PARTS & SERVICE NEWS

REF NO.	AT03244
DATE	Dec. 26, 2003
(C) Page 1 of 10

SUBJECT: WA700-3/WA800-3/WA900-3/WA1200-3
REPAIR OF BACKLASH AT ARM REST AREA

PURPOSE: To introduce modification procedure to repair the backlash of the AJSS arm rest section on WA700-3, WA800-3, WA900-3 and WA1200-3 wheel loaders

Fig. 5

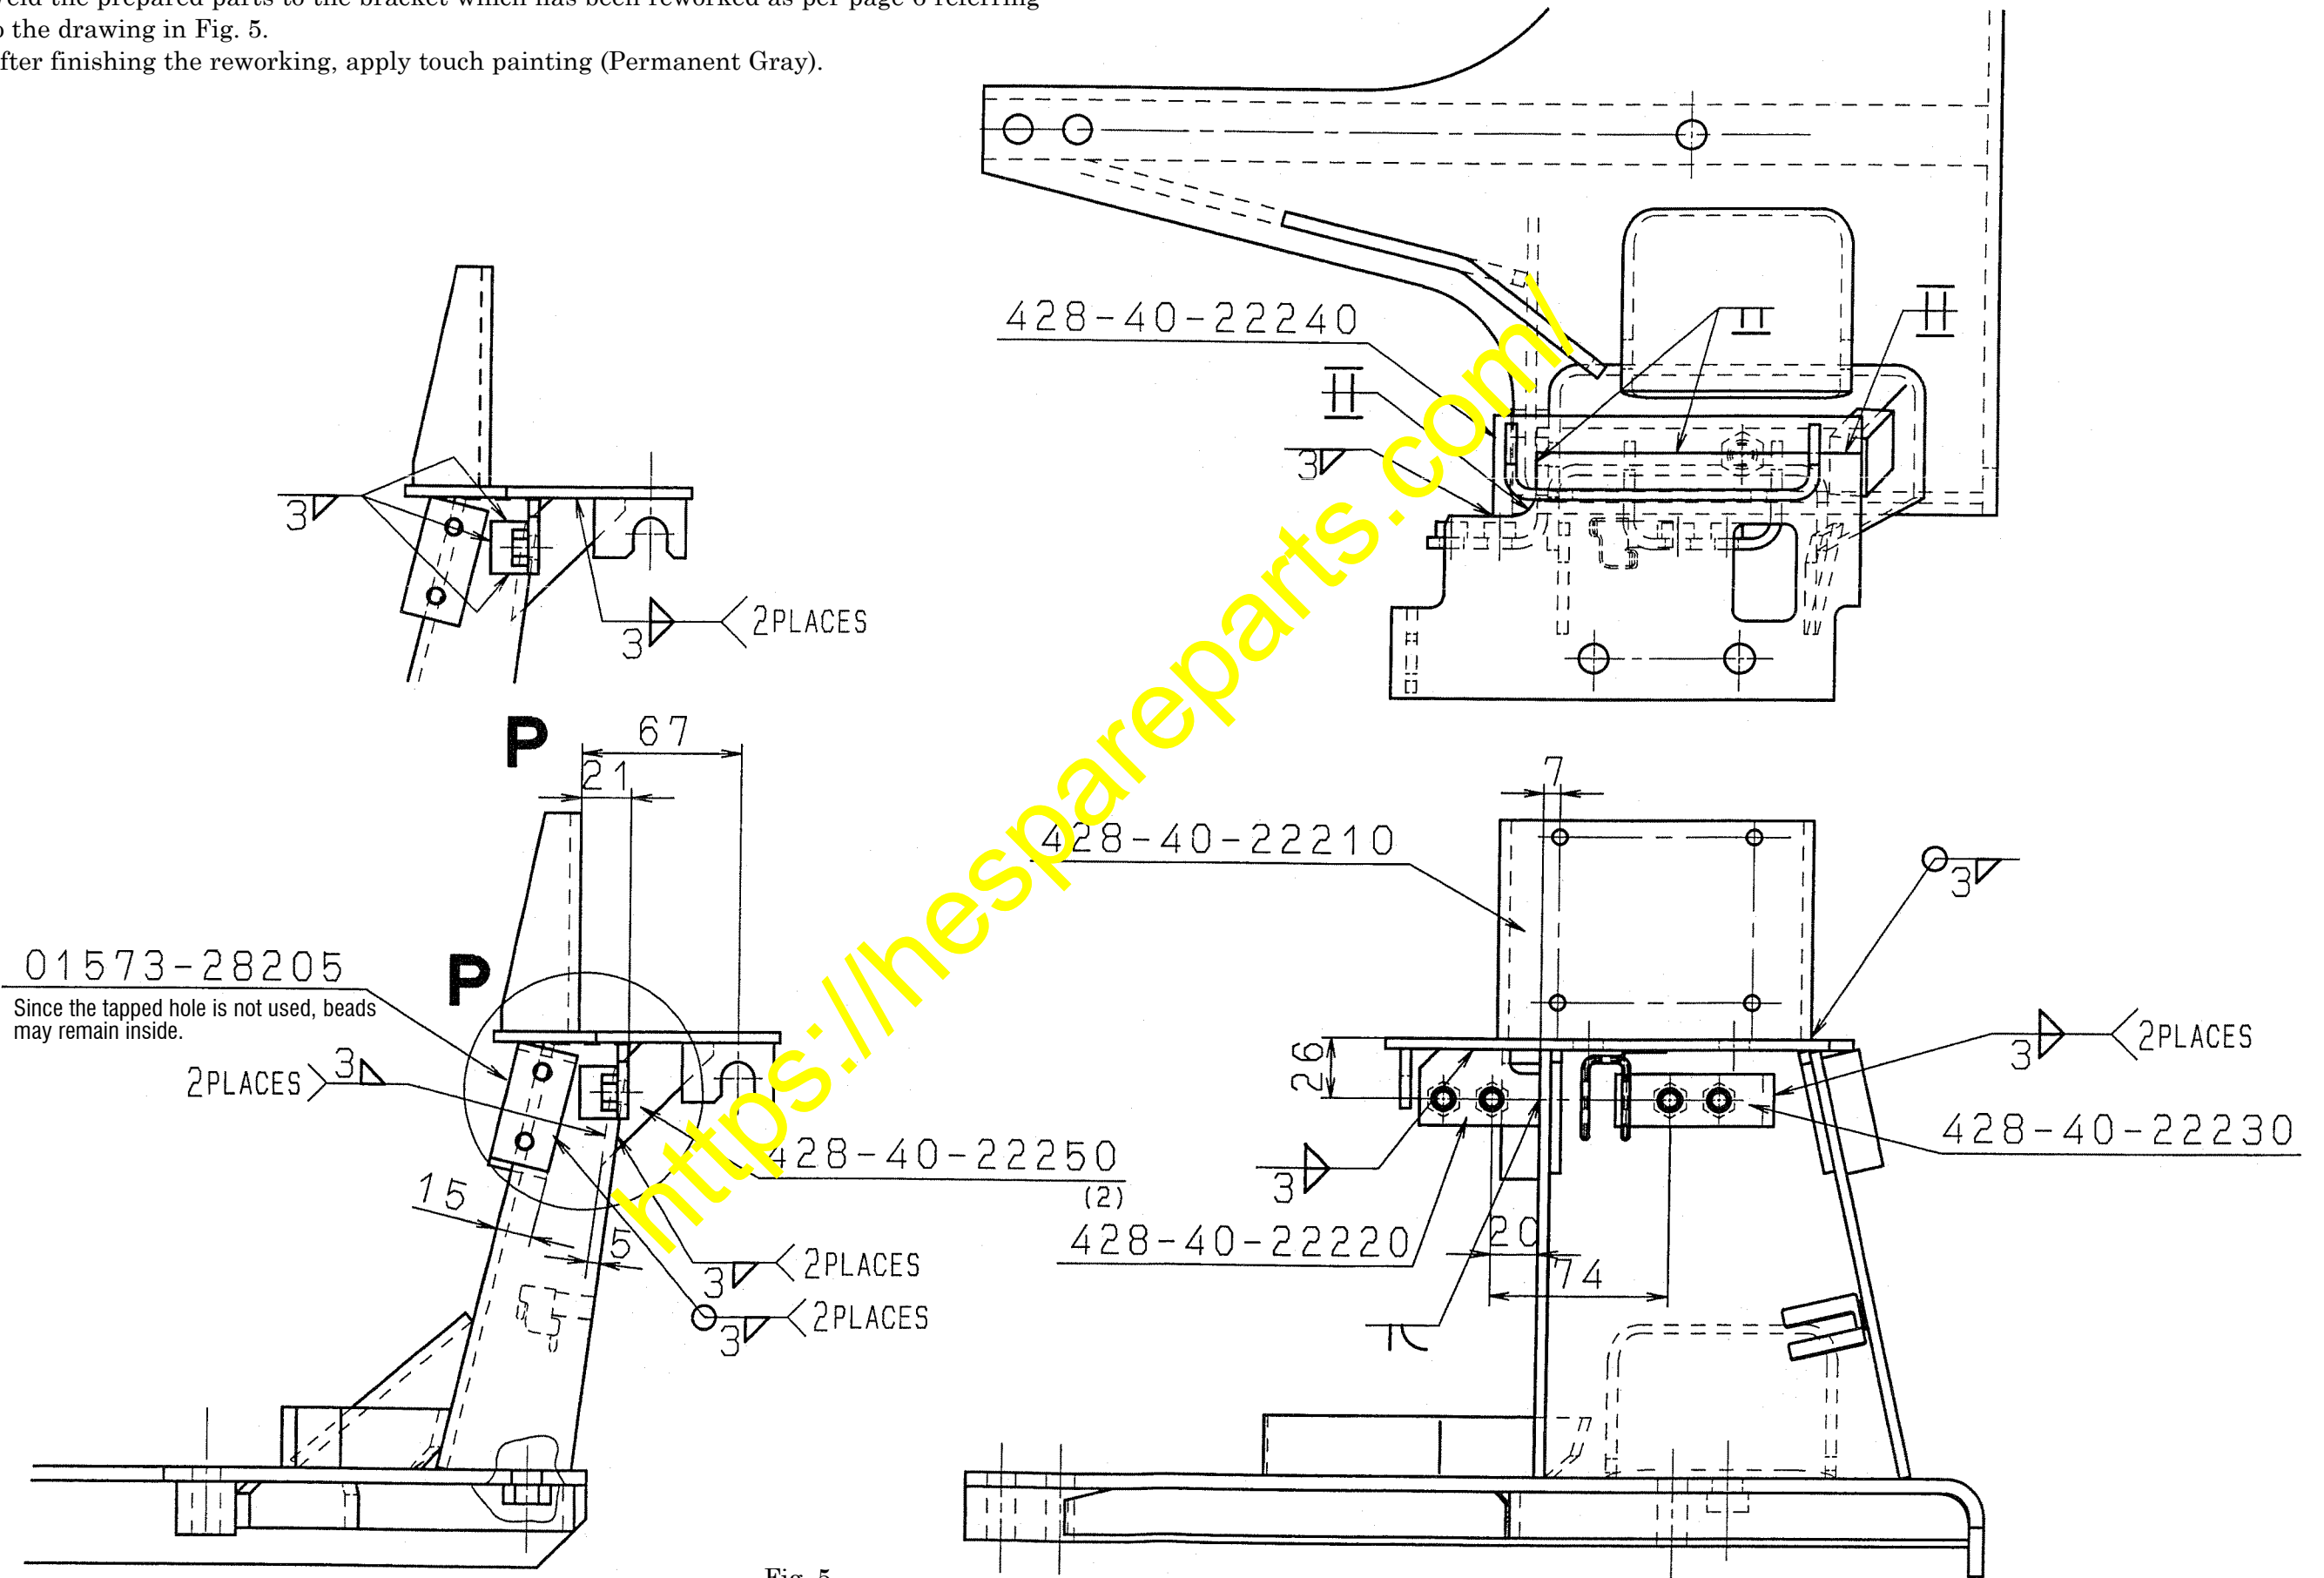
- (1) Weld the prepared parts to the bracket which has been reworked as per page 6 referring to the drawing in Fig. 5.
- (2) After finishing the reworking, apply touch painting (Permanent Gray).

Fig. 6

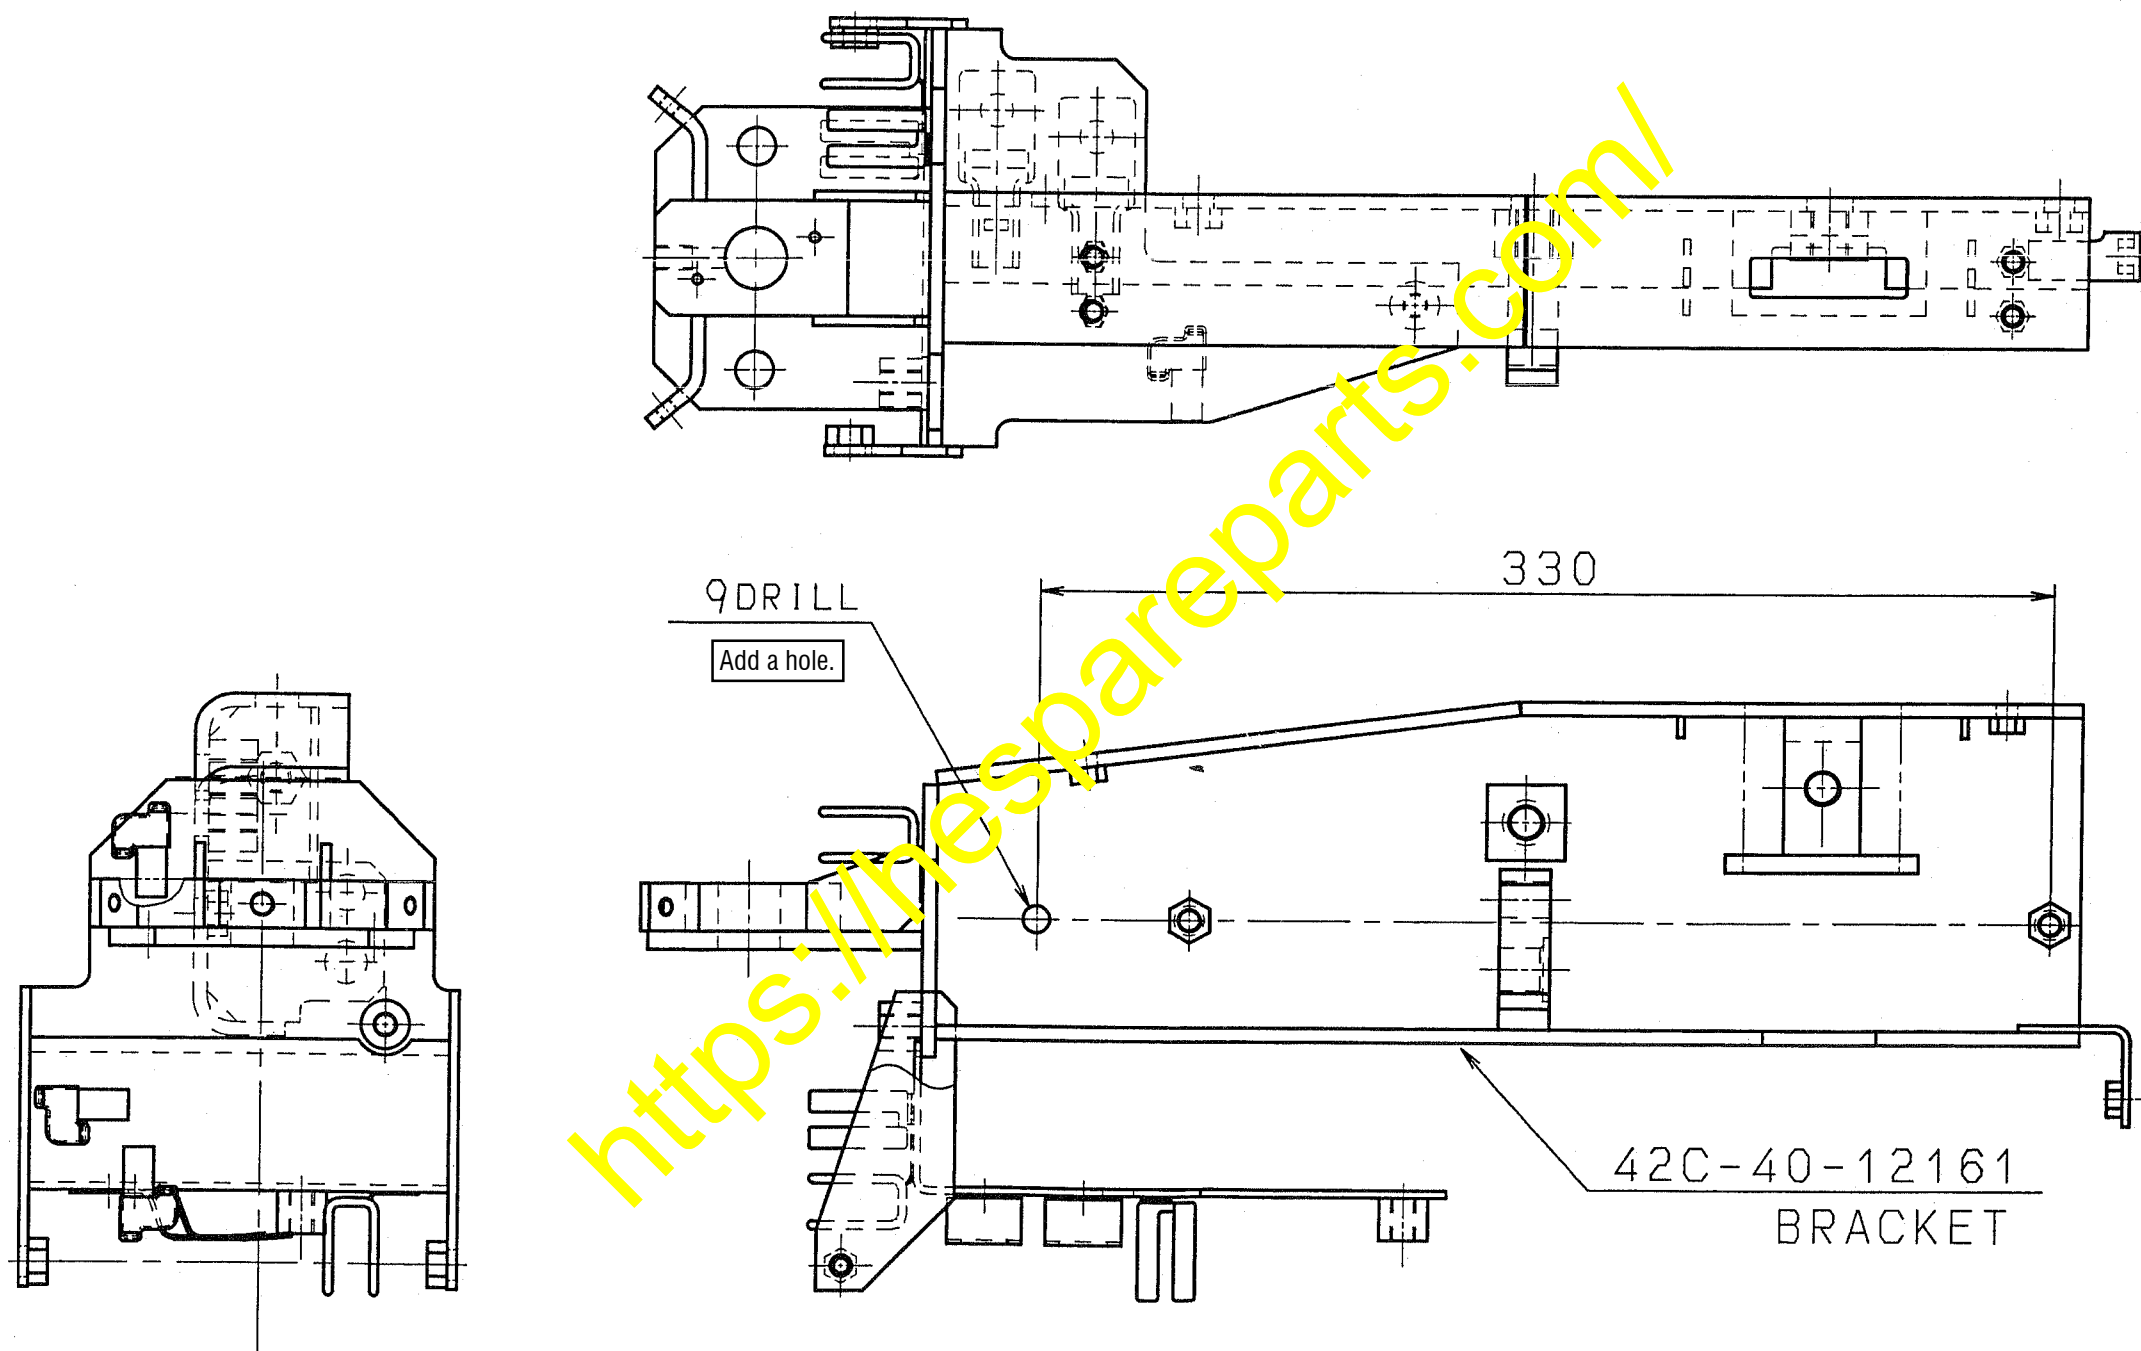
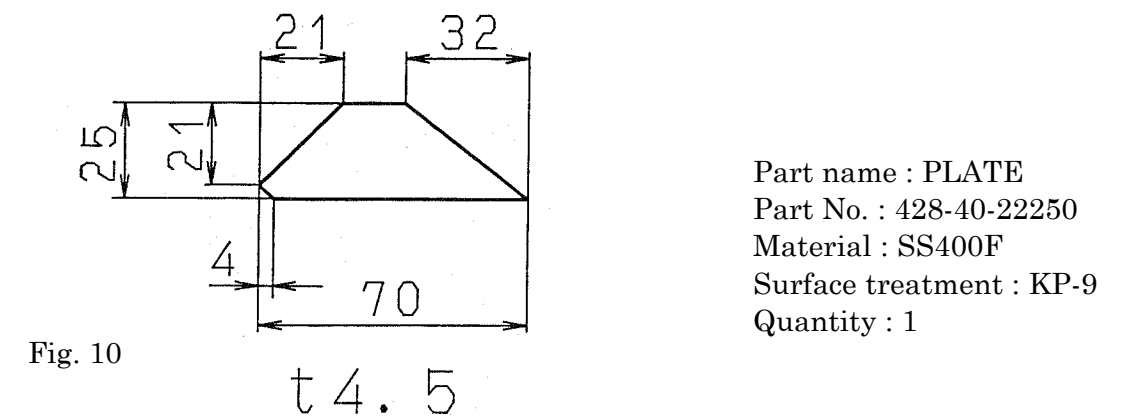
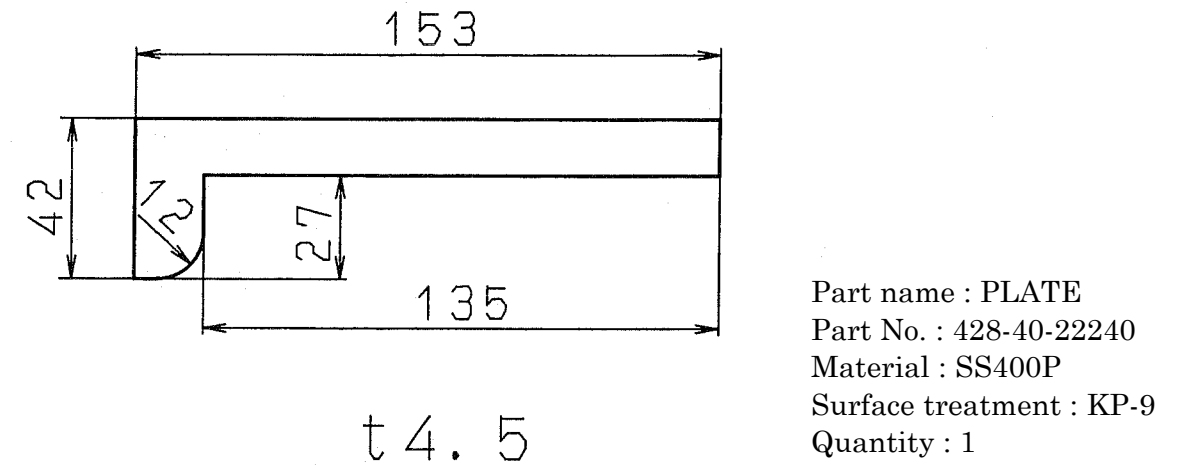
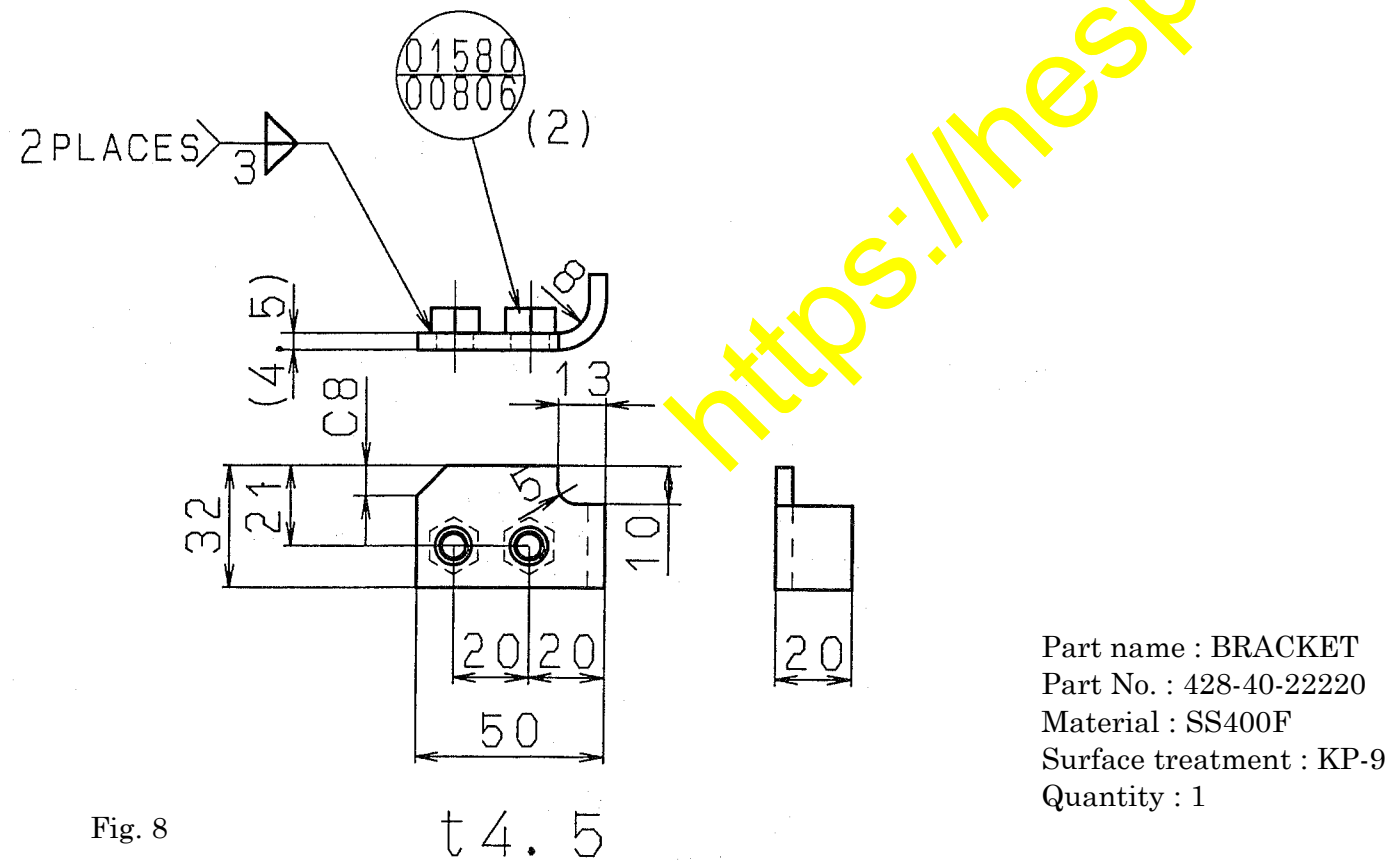
- 2) Reworking of the AJSS slide bracket
Add a $\phi 9$ hole to the arm rest base (42C-40-12161) at the position shown in Fig. 6.
